# New Service Station at 2135 Washington Avenue

Service Station at 21-35 Washington Ave, corner of Cumberland  
2/13/63

Permit to construct a one story three-bay service station 62'6" x 29'4" as per revised plans and specifications received April 29, 1963 and in accordance with Mr. Sears letter of March 13, 1963 is being issued subject to compliance with the following:

Although the appeal under the Zoning Ordinance for new service station at the above named location in this City has been sustained conditionally, permit for its erection cannot be issued until information indicating compliance with Building Code requirements has been furnished. Rights granted under the appeal will expire unless work is started within six months of the date on which the appeal was sustained. Items and details in question are as follows:

872

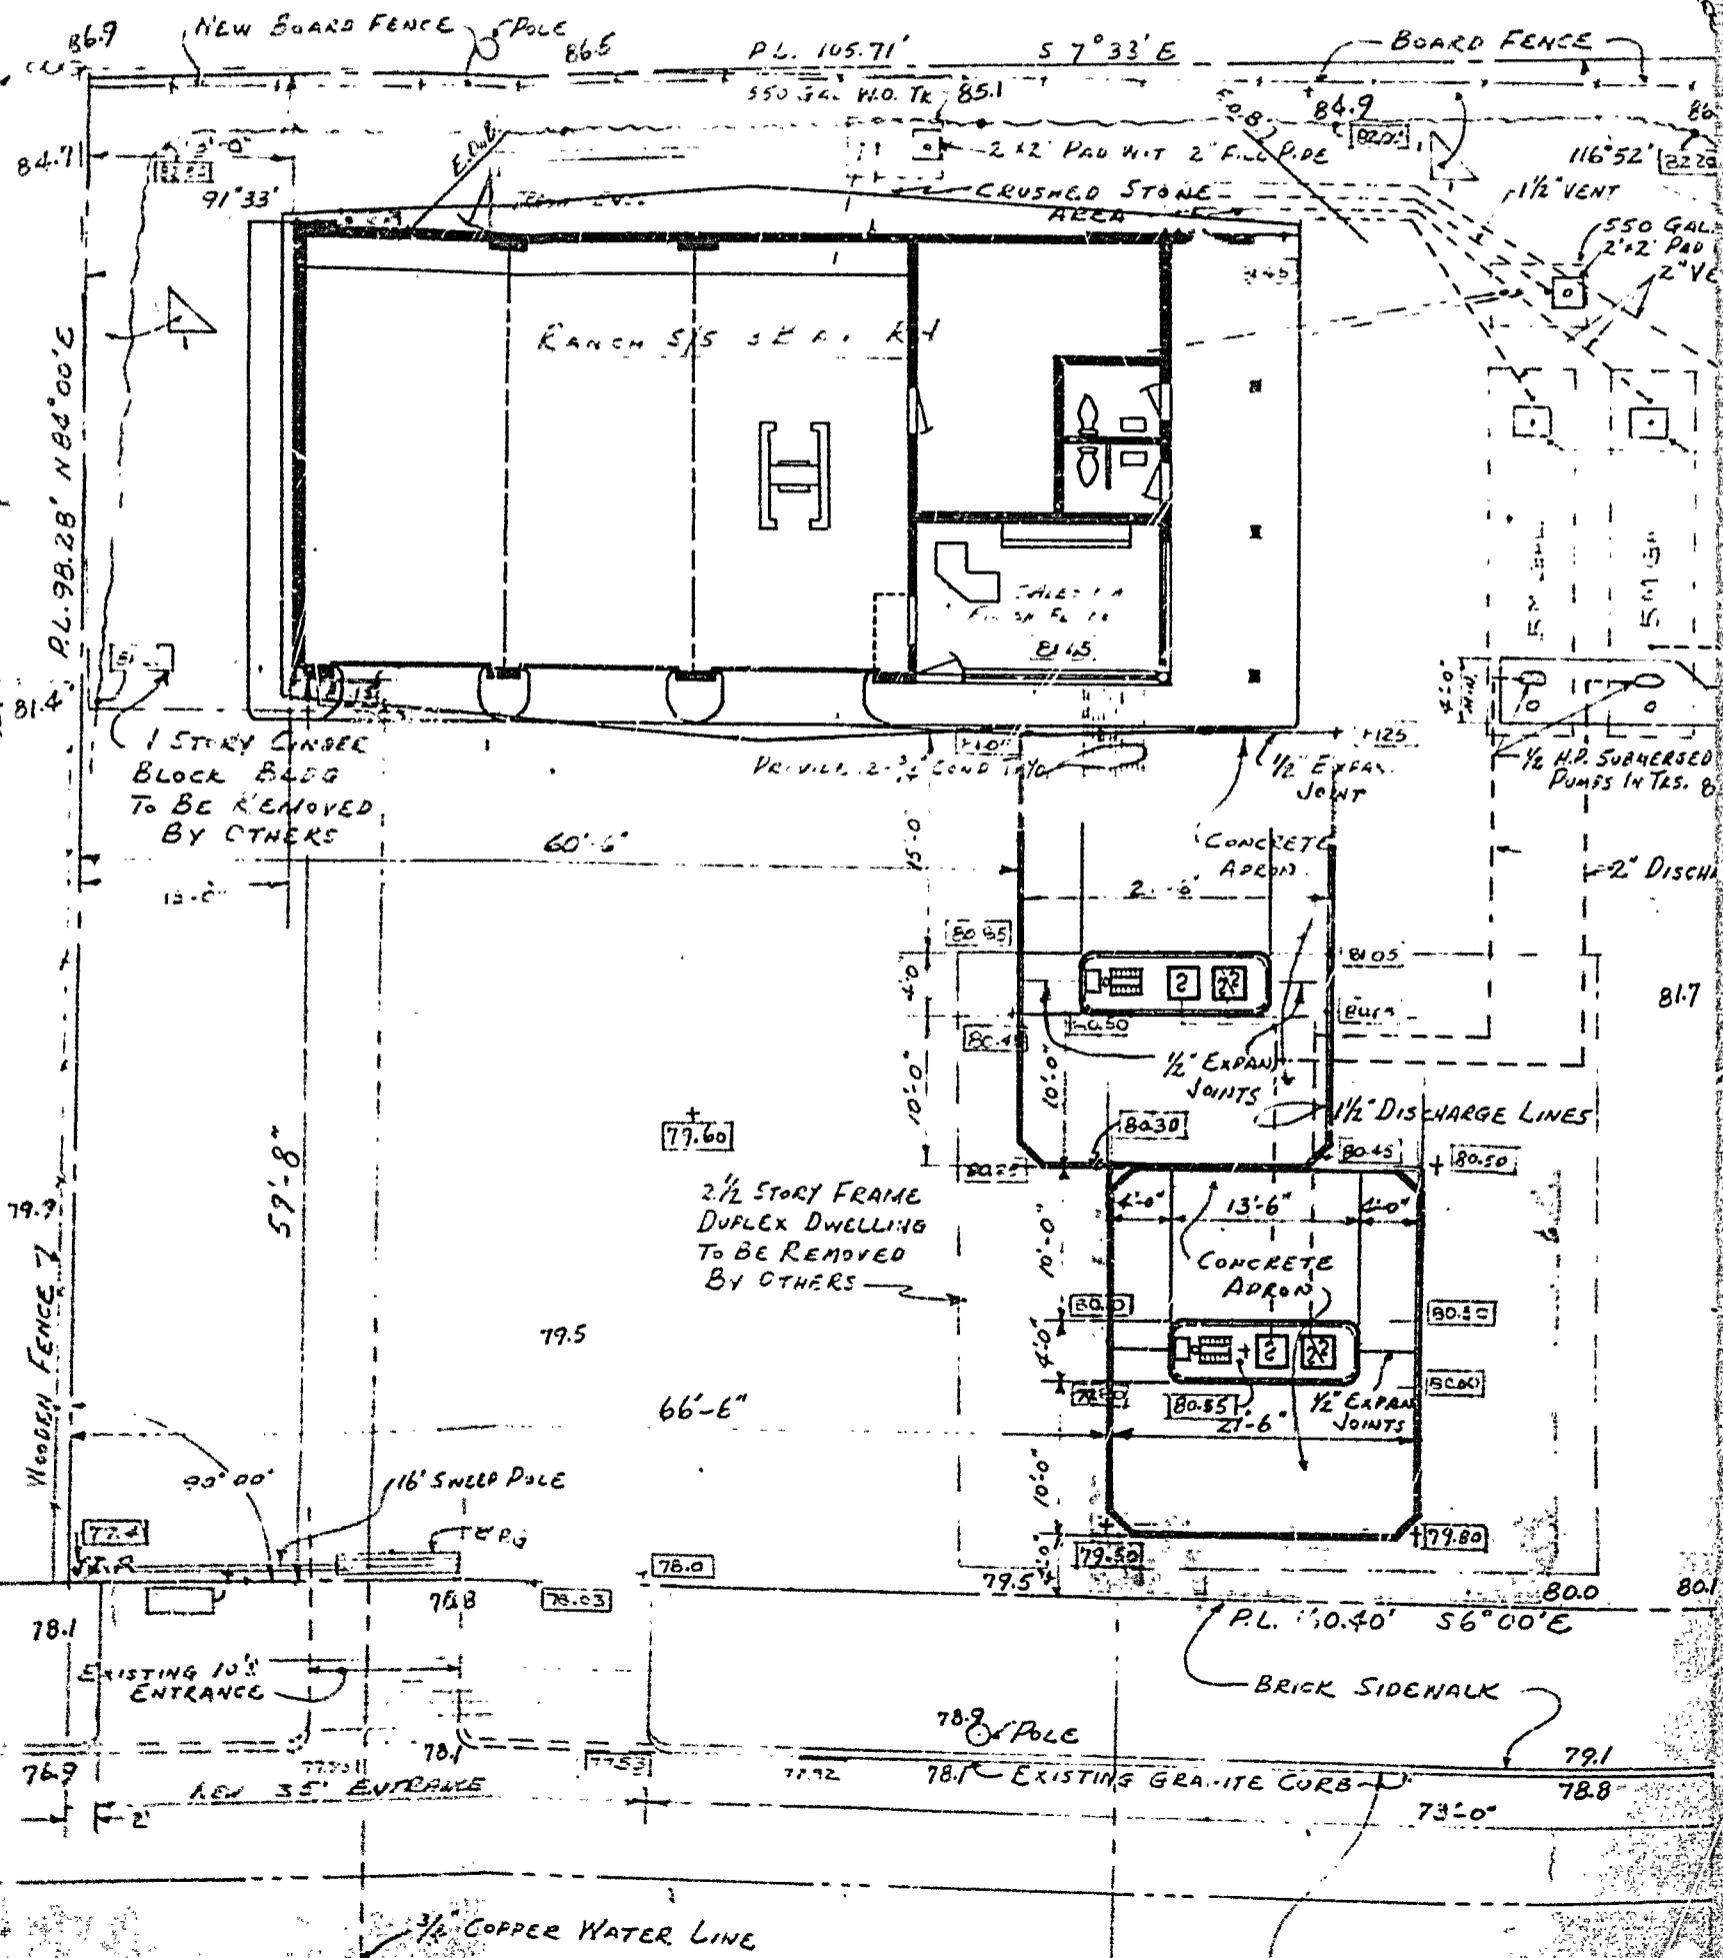
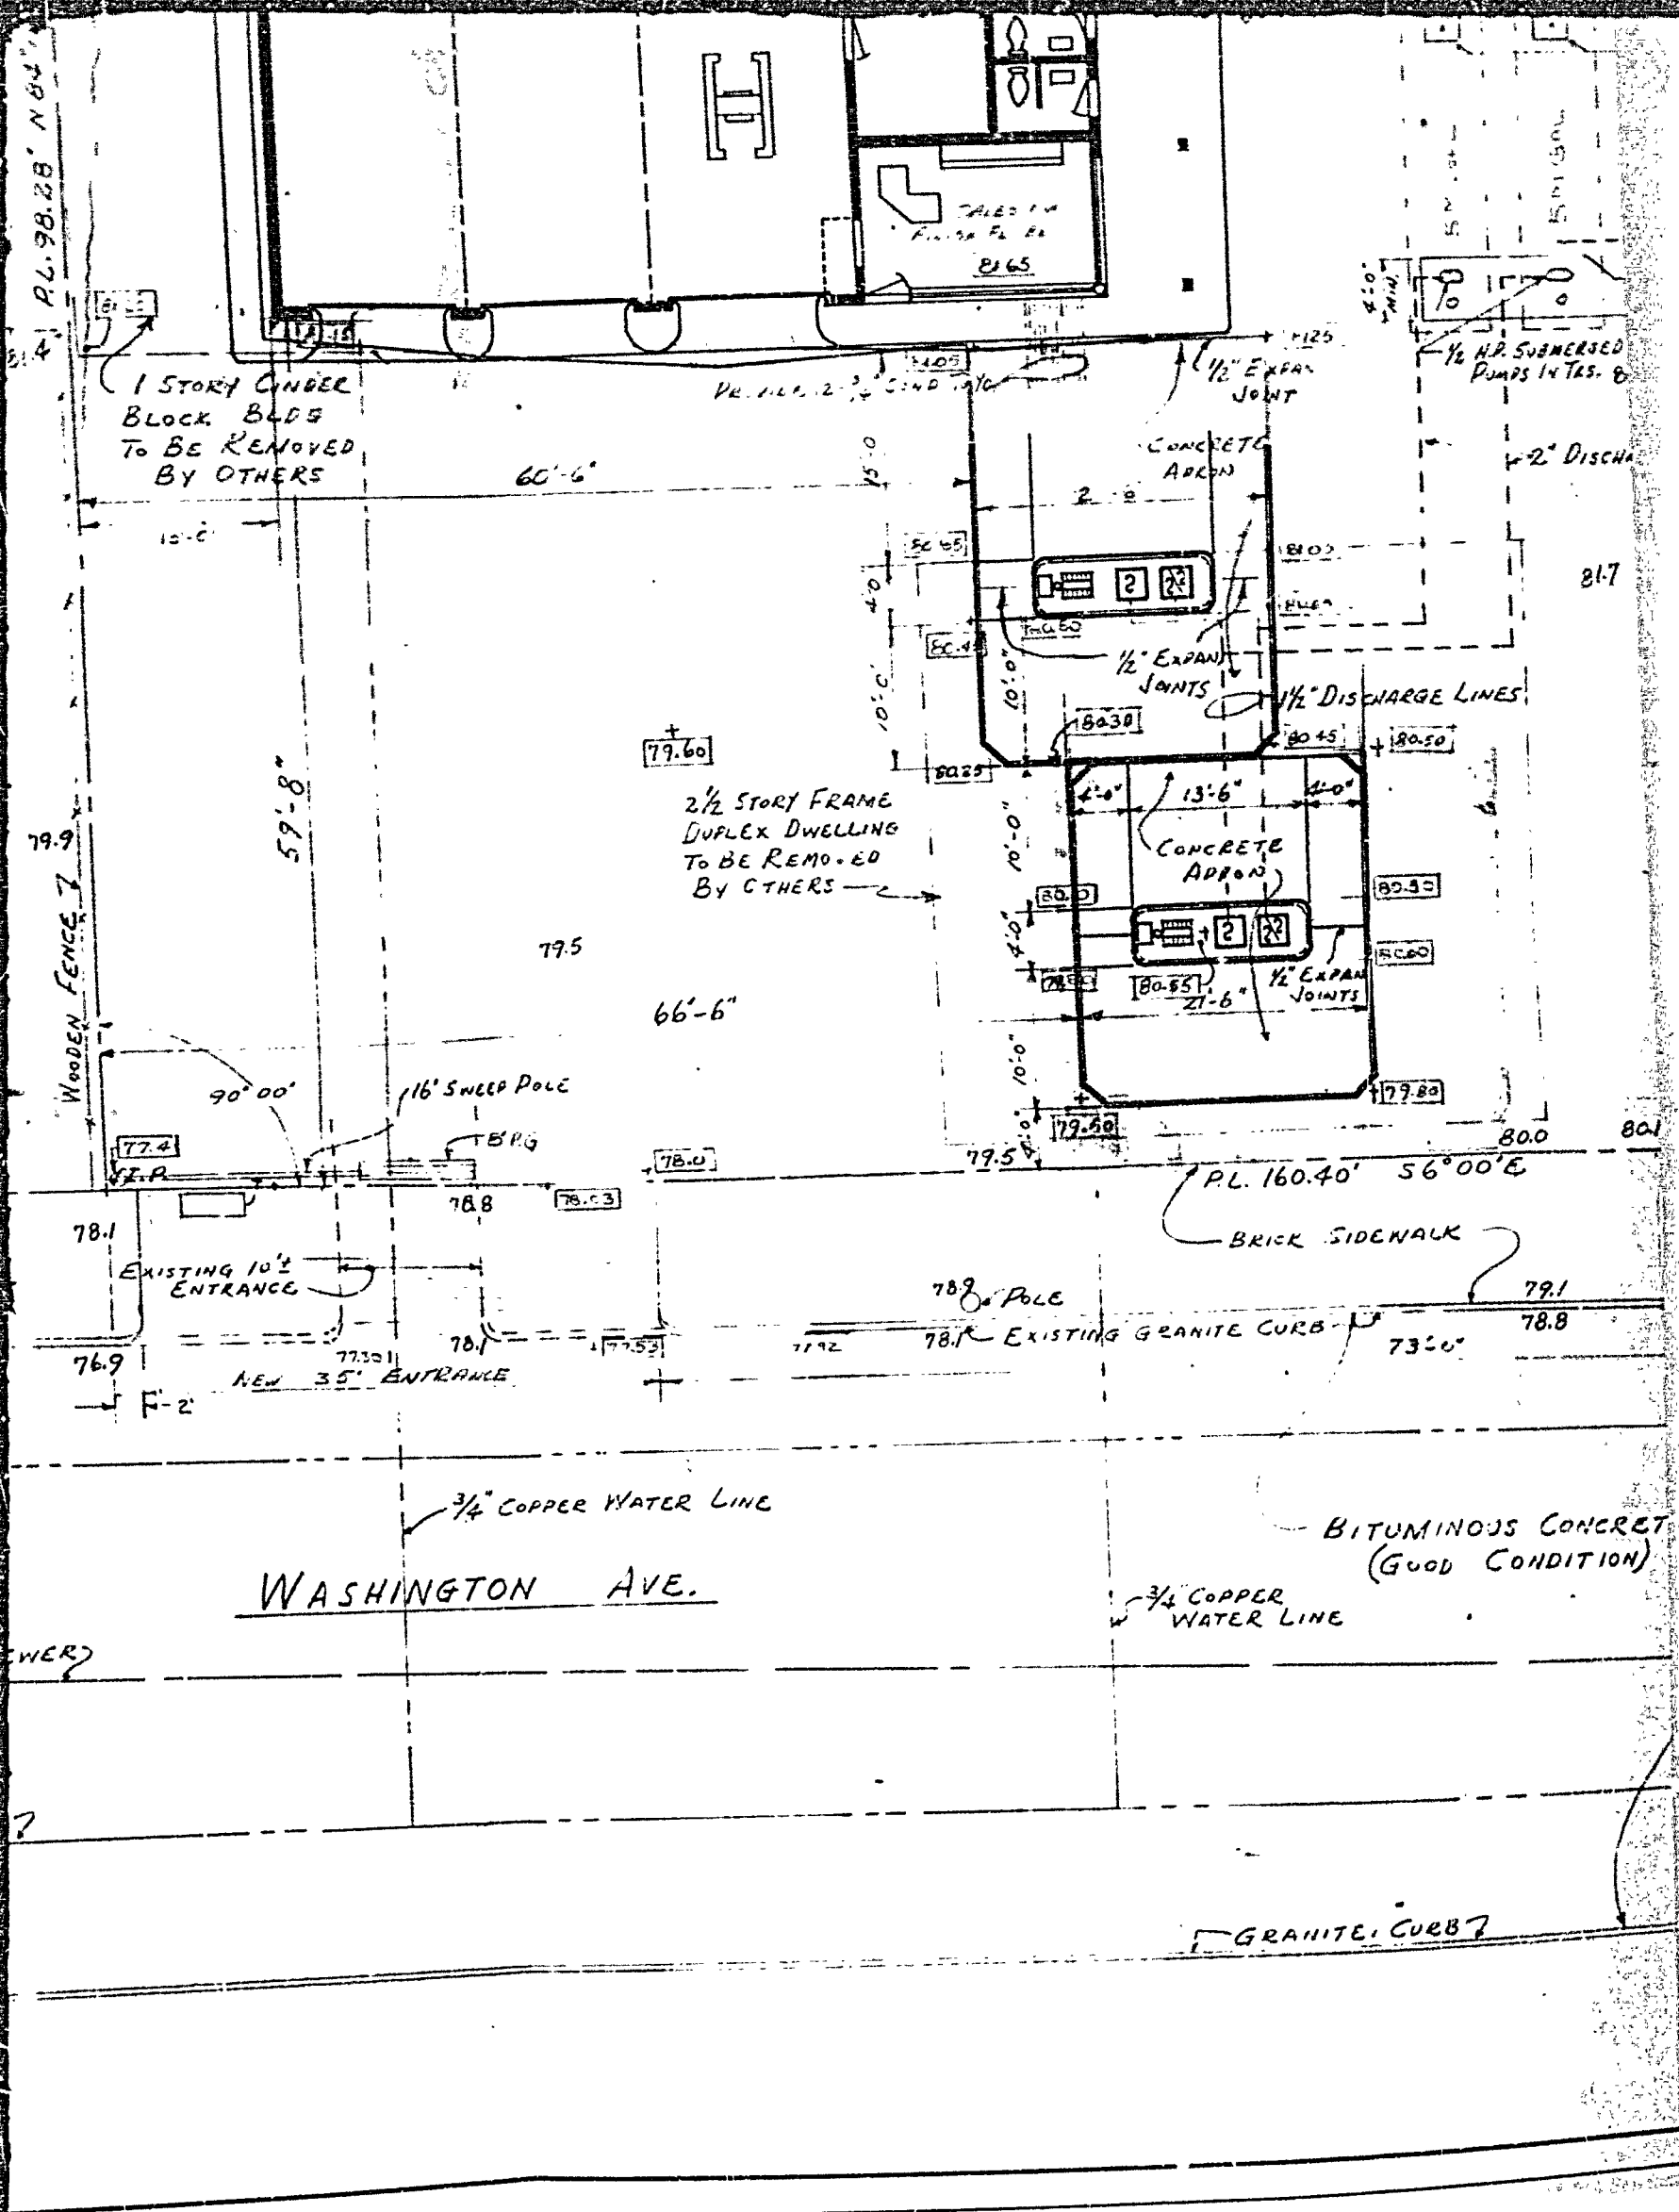
OK as to location and  
dimension of driveway opening.

OK as to location and  
dimensions of driveway openings.  
A.H. Connor
